# SERVICE BULLETIN #1

## THIS IS SPINAP TAP PINBALL (TAP)

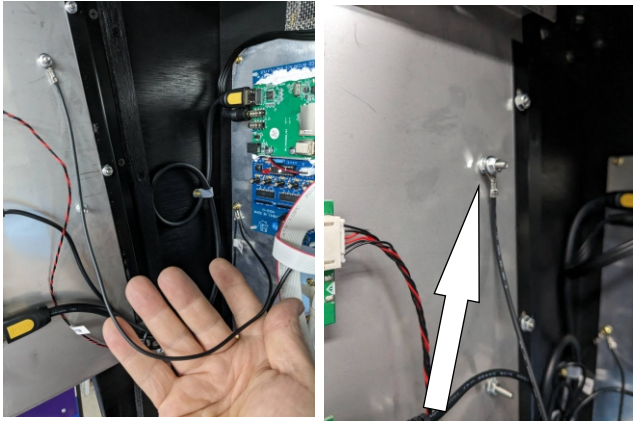
Fit earth cable & ensure  
earth screws are installed

Symptom: Faint background hum & noises in speakers when machine is in game over mode

Action: Ensure the two earth screws are in place and add earth wire shown below

Add earth wire - DO NOT undo the existing nut, add a second nut.
